PROJECT: PARCEL 4&5, HOGWOOD FARM, WOKINGHAM

PROPOSAL: INTERNAL ESTATE ROAD LAYOUT

COMBINED STAGE 1 & 2 ROAD SAFETY AUDIT

DOCUMENT CONTROL – REPORT REFERENCE: 2025/018/0570-02

Appendix C – Problem Identification Plan

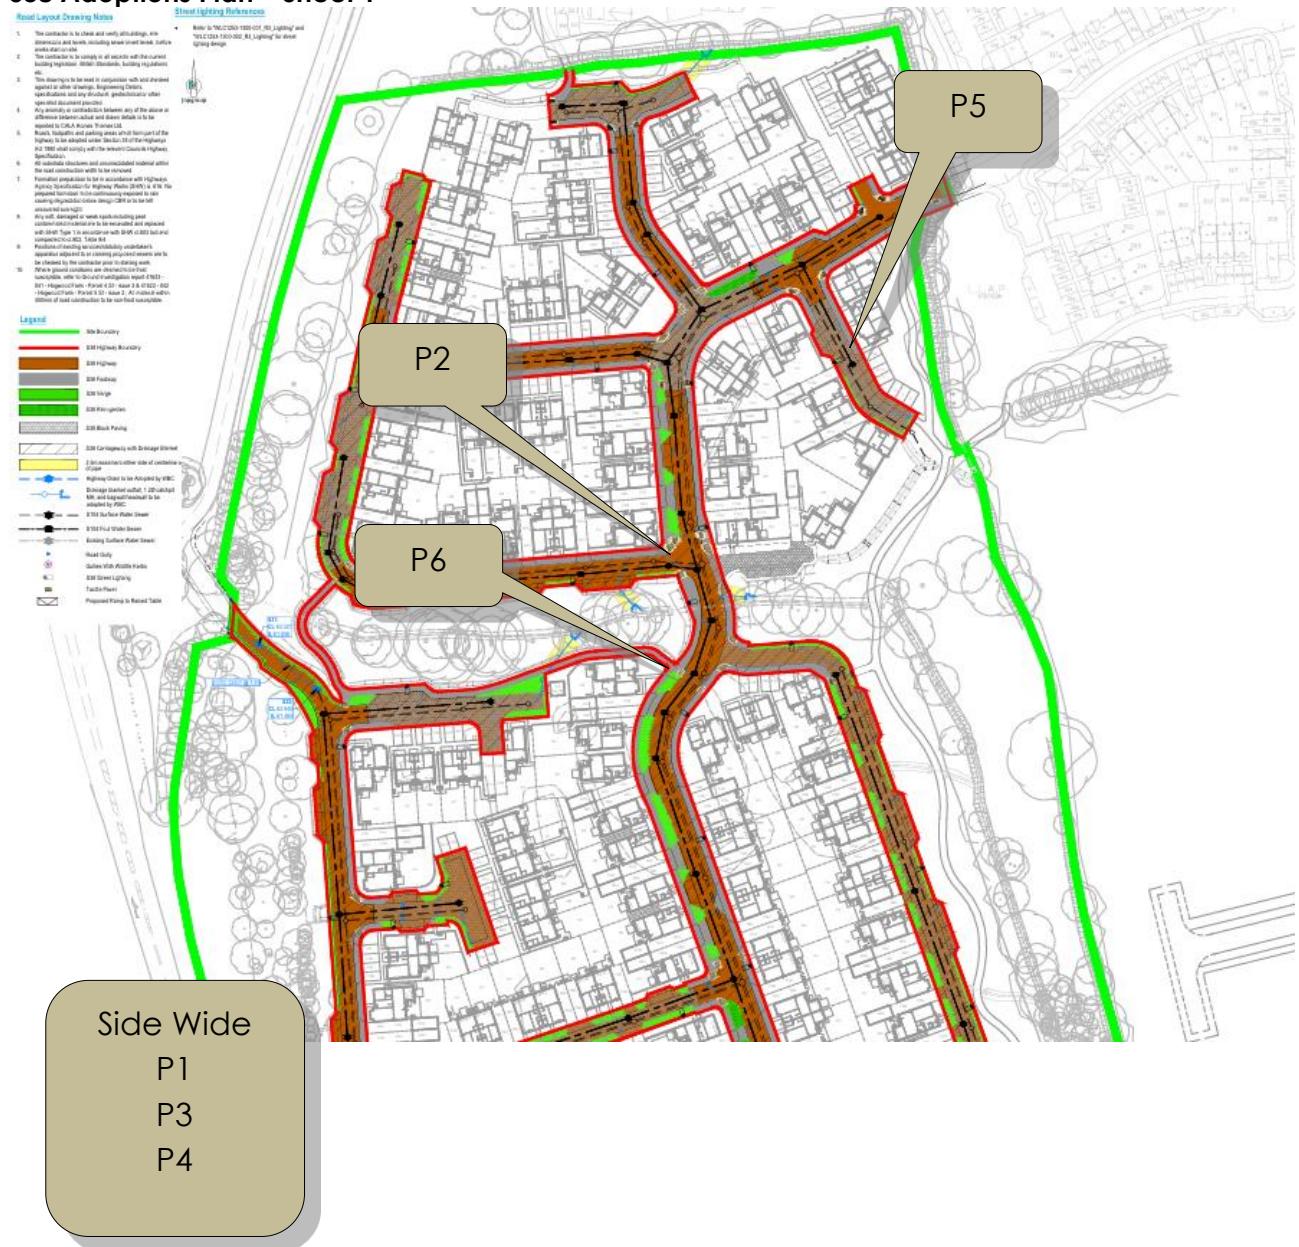
- 1.11 Unless general to the scheme, each problem has been identified with reference to key features as well as being marked on the problem identification plan presented in Appendix C.

At the pedestrian crossing, tactile paving has been installed; however, the adjacent kerb is flush (0 mm upstand) with the carriageway. The absence of a kerb upstand removes a key physical cue used by visually impaired pedestrians to detect the edge of the footway

The alignment of the pedestrian crossing points at the arms of the junctions are staggered with each crossing aligned diagonally in relation to each other. This may encourage pedestrians to change direction mid-crossing and may cause confusion to pedestrians with visual impairments.

No interfacing levels between the adopted roads and external landform are provided. Steep level differences could lead to pedestrian falls resulting in injury.

Road 1 within the development is approximately 70m in length from P881 to its junction with Road 13. With only a small build-out to control vehicle speeds to 20mph. The straight alignment and absence of significant speed-reducing measures may encourage higher approach speeds, particularly in the absence of speed enforcement or strong visual cues to slow drivers down.

The absence of a designated turning facility at the end of Road 2 could result in vehicles reversing a distance of 50m in a shared space environment and onto the main spine road through the development. Vulnerable road users, such as pedestrians and cyclists, will be at increased risk due to reduced driver awareness. Driver visibility of oncoming vehicles at the junction will also be reduced as a result of a vehicle leaving in a reverse gear risking junction pull out type collisions.

Where the tactile paving is too shallow, visually impaired pedestrians with larger strides, or those moving at speed, may overstep the tactile surface current positioned inline, without receiving the necessary tactile cue, and step out into the highway carriageway unexpectedly, increasing the risk of being struck by a vehicle

It is recommended a positive kerb upstand of 6 mm kerb is used at the pedestrian crossing to provide a detectable edge for visually impaired users. Additionally, ensure appropriate drainage falls are incorporated to prevent ponding on the tactile paving and reduce the risk of slips in cold weather conditions.

It is recommended the pedestrian crossing are aligned to provide straight, continuous routes across the carriageway in accordance with Inclusive Mobility (DfT) and Manual for Streets to minimise confusion, in particular for those who are visually impaired.

It is recommended that interfacing landform levels are checked adjacent to the adopted highway, to ensure no significant change in levels are apparent that would result in the likelihood of falls occurring. Where this occurs, levels should be regraded, or fences / barriers installed to prevent such incidents occurring.

It is recommended that additional horizontal and/or vertical measures are proposed to attain a design speed of 20mph.

It is recommended that formal turning facilities appropriate for the largest vehicle requiring regular access are provided.

It is recommended that the tactile paving is extended to a minimum depth of 1.2m for these inline crossings in accordance with current standards and guidance to ensure effective warning for all users, especially those with visual impairments.
